MEMORANDUM

SUBJECT: Review of the Energy Fuels Resources (USA) Inc. (EFR), White Mesa Uranium Mill, Blanding, Utah September 27, 2023, Source Assessment Report for Selenium in Monitoring Well MW-11 and pH in Monitoring Well MW-37 Ground Water Discharge Permit No. UGW370004 (Permit)

Figure 1 – Historical Selenium Data Plot at MW-11

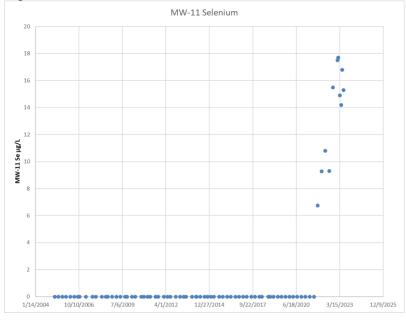
The selenium data set in MW-11 depicts a significantly increasing trend since first testing over the reporting limit during the 4th Quarter 2021 sampling event.

Figure 2 – Historical Field pH Data Plot at MW-37

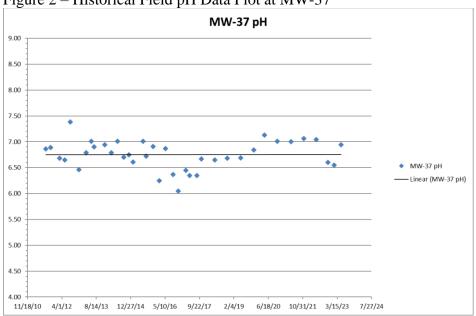
The field pH data set in MW-37 does not exhibit a significant decreasing trend and exhibits a non-parametric distribution.

The SAR notes that pH at MW-37 was decreasing prior to 2016 and may have resulted from pyrite oxidation, since visible pyrite was noted in the drilling log. After 2016, the stable to increasing pH trend (reflected in most of the MW-series wells) cannot result from TMS seepage mixing into groundwater since the TMS solutions have a very low pH. The field pH data set in MW-37 does not exhibit a significant decreasing trend and exhibits a non-parametric distribution as shown in Figure 2.

Figure 4 –Plot of Post-2016 pH Data at MW-11

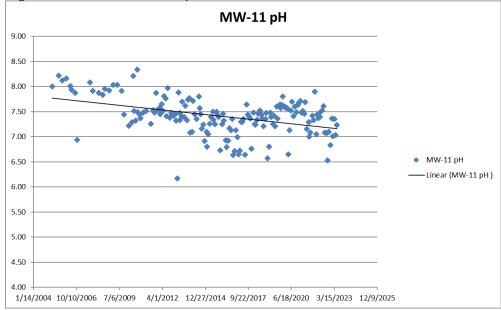
DWMRC review of the SAR notes that field pH in nearly all MW-series monitoring wells, including MW-11 and MW-37, was decreasing prior to about 2016 (Figure 2 and Figure 3). This has resulted in mobilization of pH sensitive metals and increases in concentrations of these metals in groundwater. However, since about 2016, the site-wide decreasing pH trend has reversed in nearly all MW-series monitoring wells (including MW-11 and MW-37), and pH is now generally stable to increasing (Figure 4 and Figure 5). This includes upgradient and far cross-and downgradient monitoring wells. The SAR states that the post-2016 increase in pH is inconsistent with a TMS source as TMS solutions have a low pH, and mixing of potential seepage of TMS solution with groundwater would cause a decrease (rather than increase) in pH. The increasing pH post-2016 shows that MW-11 and MW-37 are unimpacted by the TMS.

Figure 6 – Chloride Plot of Historical Data at MW-11

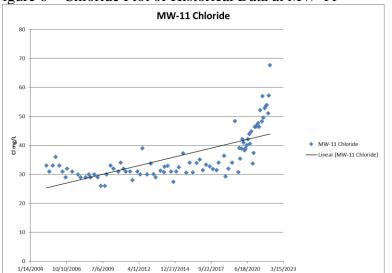
Per the SAR, the increase in chloride has occurred "only since about 2018, correlates to an increase in nitrate, and is due to the migration of the nitrate/chloride plume towards MW-11."

Figure 7 – Fluoride Plot of Historical Data at MW-11

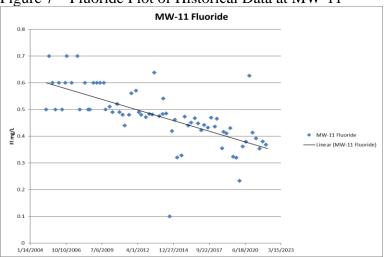
Fluoride is highly concentrated in tailings wastewater. Literature and transport modeling has shown fluoride to be highly mobile in the vadose zone and groundwater beneath the tailing cells. Per the figure below, fluoride is showing a decreasing concentration trend in MW-11 indicating that MW-11 is not impacted by potential seepage from the TMS.

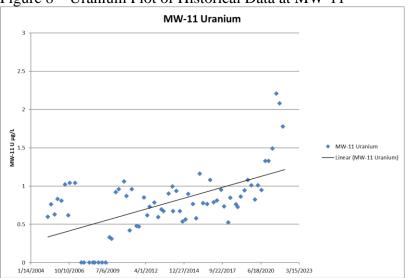
The SAR discusses that chloride, nitrate, and uranium show almost the same trend with respect to increasing concentrations. Chloride and nitrate are anions that do not sorb onto aquifer materials and are not retarded with respect to groundwater flow. In contrast, uranium is expected to have a mobility that is orders of magnitude lower than chloride or nitrate at the near-neutral pH conditions at MW-11.

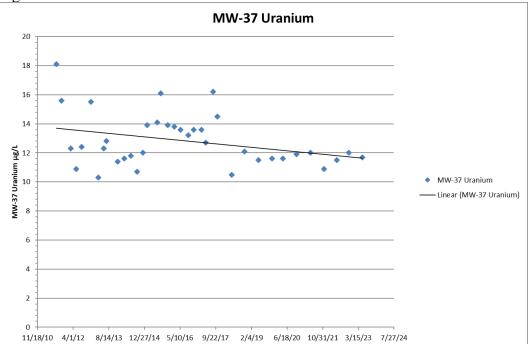
Mann-Kendall test results included in the SAR show that no significant trends exist for MW-37 indicator parameters. Linear regression test results for normally distributed constituents, chloride and uranium show a decreasing trend in chloride (Figure 10) and a significantly decreasing trend in uranium (Figure 9), indicating that there has been no impact to MW-37 from potential TMS seepage.
